Consent No: **220856**
Applicant: **Rose & Brooke Teague**
Site Address: **24C Gawler Street, Te Horo**
Work Type: **4-bedroom dwelling with 2.5 bathrooms, attached double garage. Clad with Brick Veneer and EZPanel 50mm ACC Concrete Panel cladding.**

GoGet Inspection Audit Report

Consent No: **220856**
Applicant: **Classic Builders Wellington Limited**
Site Address: **24C Gawler Street, Te Horo**
Work Type: **4-bedroom dwelling with 2.5 bathrooms, attached double garage. Clad with Brick Veneer and EZPanel 50mm ACC Concrete Panel cladding.**

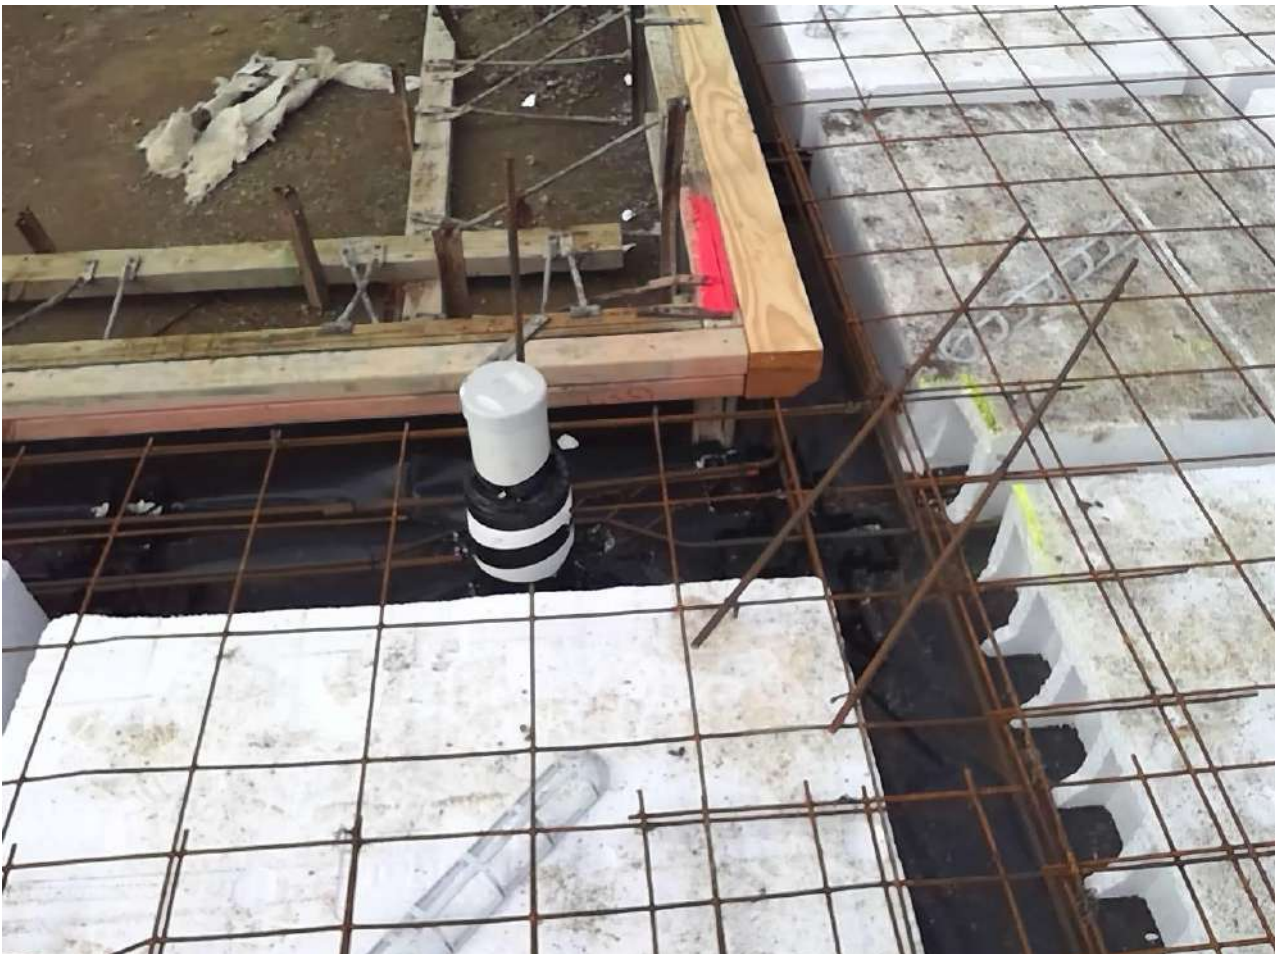
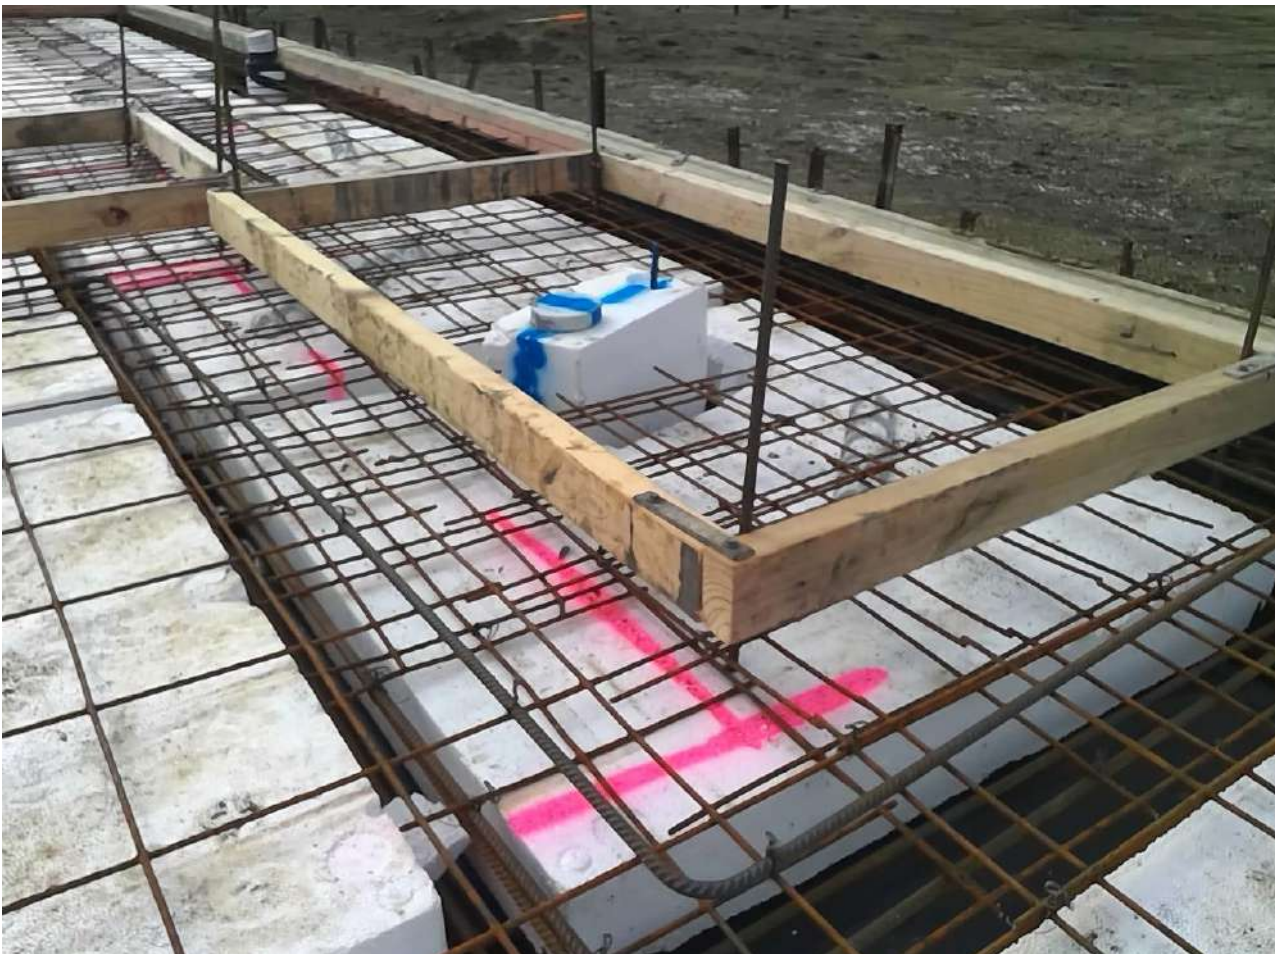
Inspection Element	Status
General	Fail
Engineers details required	Pass
H Wells	
Rebate for brick veneer	Pass
Ground clearance	Pass
Concrete cover	N/A
Driveway S/W control	N/A
Sand blinding	Pass
Slab thickenings	Pass
As per plan	
Vapour barrier	Pass
Bottom plate fixings	N/A
Steel reinforcing	Fail
Needs to be signed off by engineer	
Bar chairs	Pass
Bar chairs placed as required	
DPC penetrations taped	Pass
All penetrations taped as required	
Minimum floor level	Pass
Taken from datum point, as marked on plan	
Registration numbers	N/A
Siting	Pass
Well within boundaries	
Sub slab insulation	N/A
In-slab heating	N/A
LBP number	Pass
Hayden Goodin	
Agent/owner written approval	N/A
non compliance discussed onsite	Pass
Discussed with RFL guys, get engineer to approve before pouring.	
Next Inspection required	N/A
Other	N/A
